Service information

Reference no.: GDA_113604

Coffee Ground Drawer can not be inserted / does not fit - Minuto and Moltio Family.

Image1

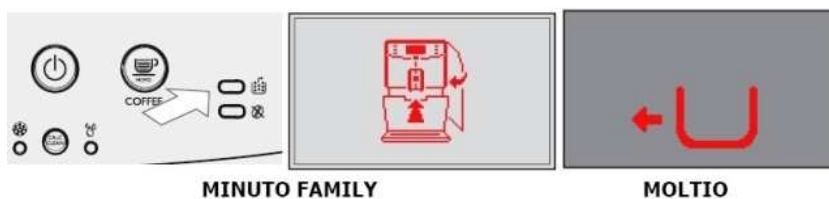
- Consumer can not remove or insert the Coffee Ground Drawer if the brew unit is not in home position;
- Machine could show error "enter the grounds container" (Image1);
- Consumer can not insert or remove the coffee ground drawer.

Image 2

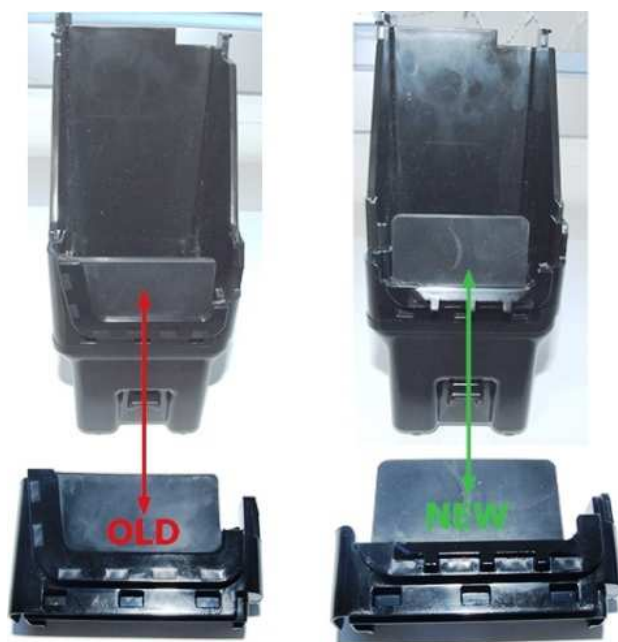
CURE: From SN TW901618261466 the insert from coffee grounds drawer has been changed to enable the insertion also with the brew unit not in home position. (Image 2)

Up to SN TW901618261465: in case of above described symptoms, replace the old insert by the new version (Image 2).

Part Code of new insert: 421944063131 - BLK DUMP BOX INSERT V2 NPR
